WEBSTER ISB
TYPE SA-630

Shop Drawing Submittal Review

Project Name: Webster University-**ISB**

Copies	No.	Description
1 PDF	265100E02	(Submittal No. 265100-005) – Indoor Lighting (& Outdoor Lighting)
		• EB, EK, RQ, & SA

XOOLINE™ HYDRA LD25 IP40*

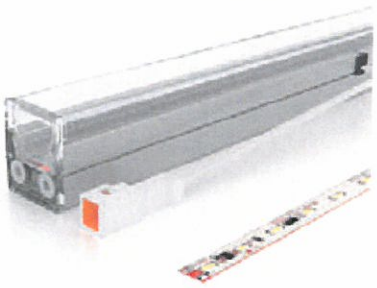
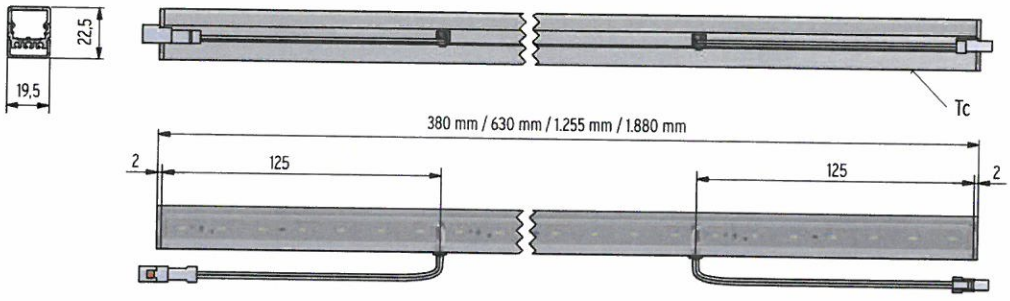
1. Coordinate all color finishes with architect.
2. Type EB: Provide W825 configuration. Coordinate and conceal wiring within guardrail to remote drivers. Provide 45 degree mounting clips. Contractor shall ensure fixtures are securely fastened to guardrail.
3. Type EK – Revise and Resubmit "D3" series in-lieu of "D4" series. This fixture is intended to aim downwards and be equipped with a lens to diffuse the view into the fixture.
4. Type RQ – Coordinate installation with existing fixtures.
5. Type SA – Revise and Resubmit. Submit Hydra LD25 linear product in-lieu of Xooline pre-configured product submitted.
